To whomever this may concern at Warwick District Council.

This is my objection to the following proposed modifications to the Warwick District Local Plan

**Mod Number:** 10, 11, 16, 19

These relate to the increase in housing density to the land (H27) South of Arras Boulevard from 100 to 130 homes and the allocation of land (H51) South of Lloyd Close for 115 homes.

*Views of Old Budbrooke Road towards Warwick Parkway Train Station (dates in March 2016)*

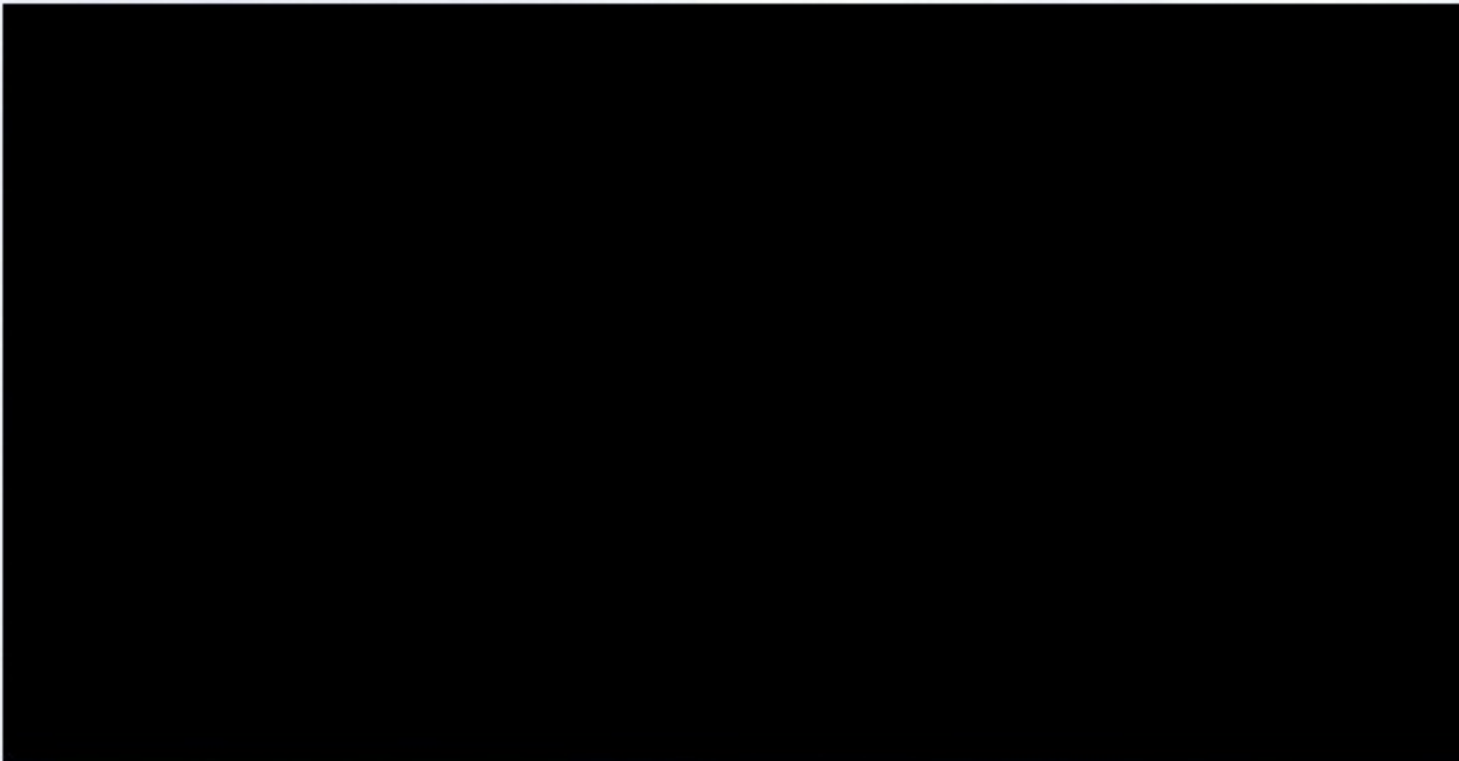
Sewerage and drainage problems persist around Hampton Mangna with roads regularly flooding during spells of heavy rain, this will become worse with additional housing:
